Amdt. to ol/change to Appendix A tech spec concerning Cask Handling.

June 24, 1976
L-76-225

Re: Turkey Point Plant Units 3 and 4
Docket Nos. 50-250 and 50-251
Proposed Amendment to Facility
Operating License DPR-31 and DPR-41

FIGURE 1

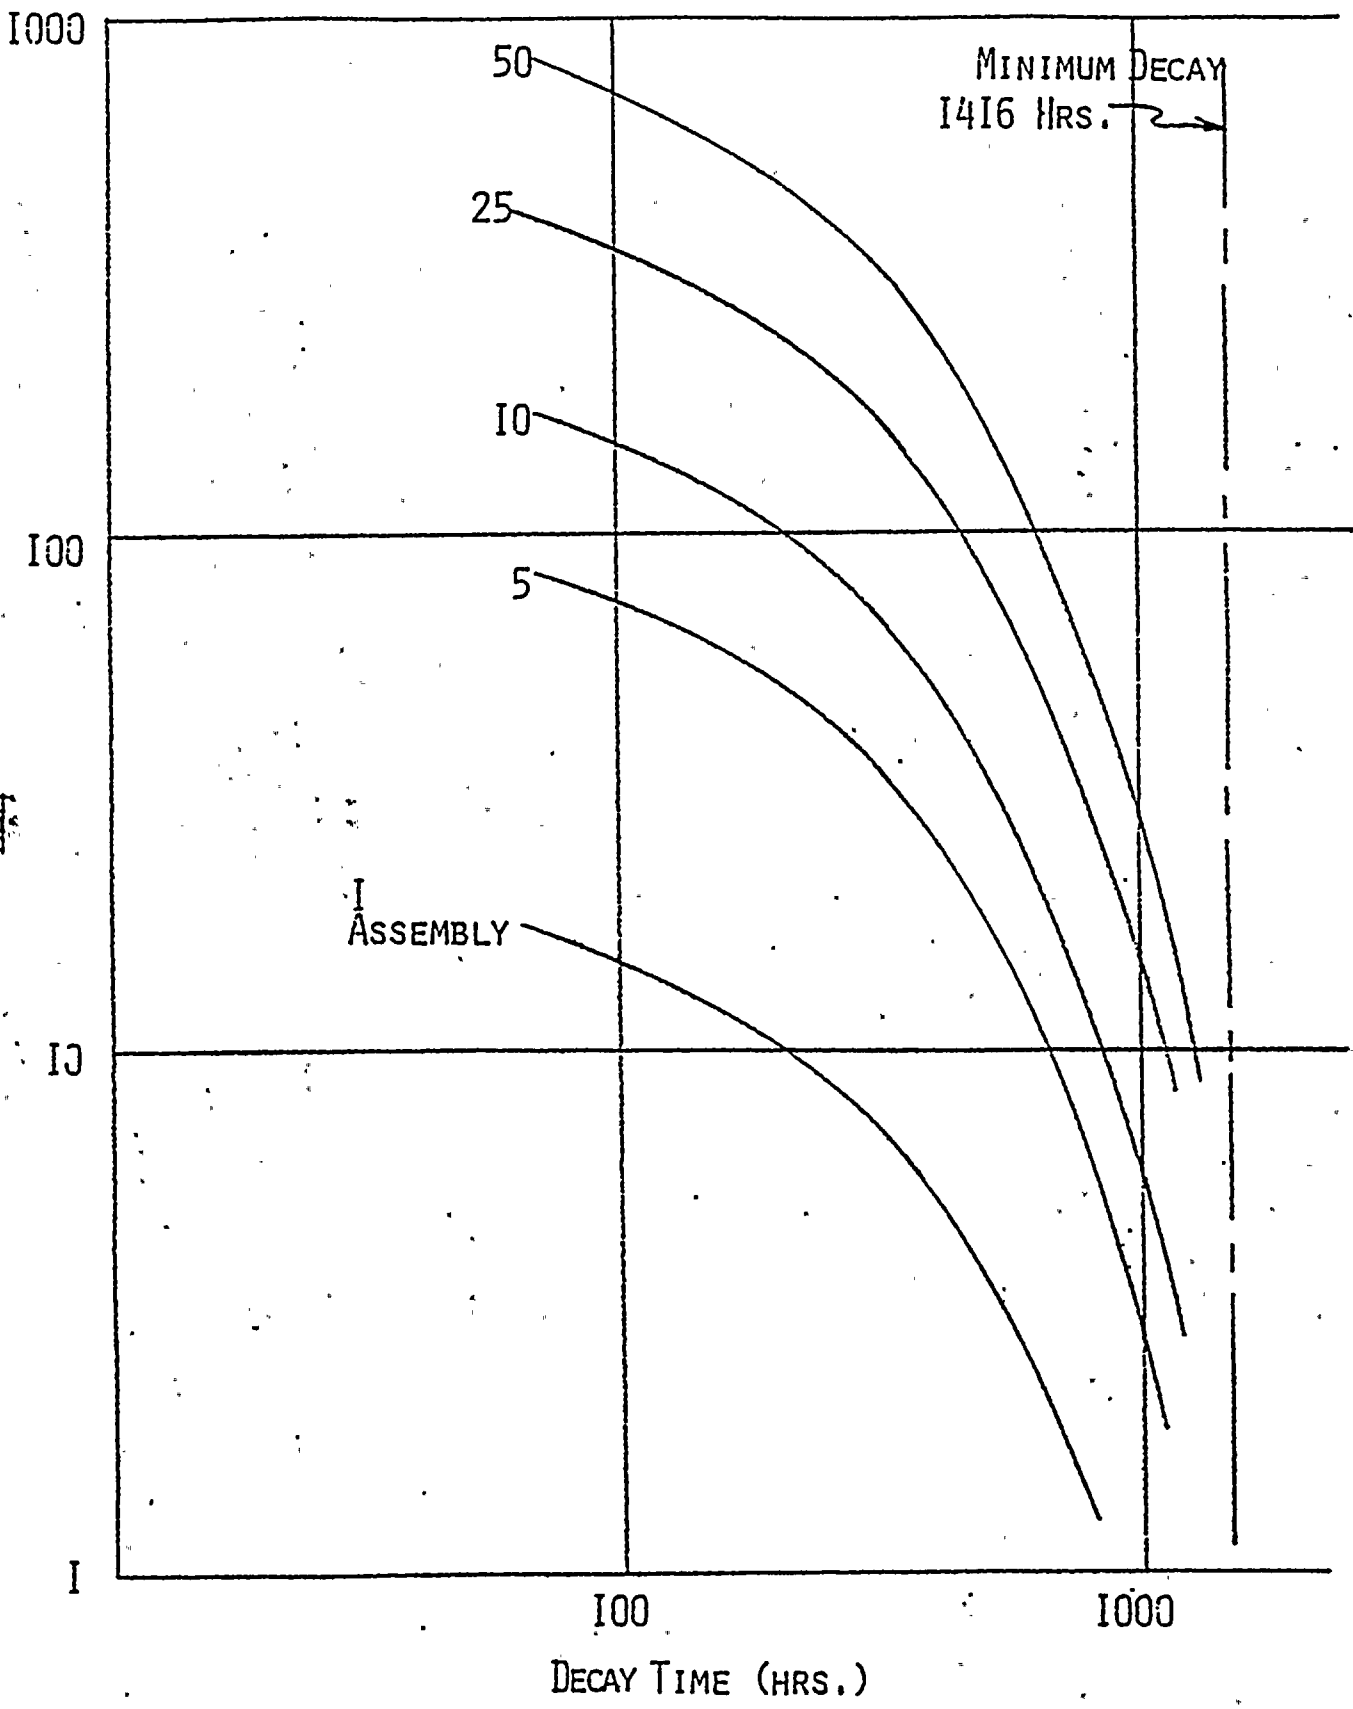
The proposed amendment also imposes a limit on the minimum spent fuel decay time required prior to lifting a spent fuel cask into the spent fuel pool. This limit further reduces the potential radiological consequences of damaged fuel elements in the unlikely event of a cask tip. Figures 1 and 2 present the results of analyses conducted to determine potential offsite doses resulting from the damage of various numbers of fuel assemblies after varying decay times.
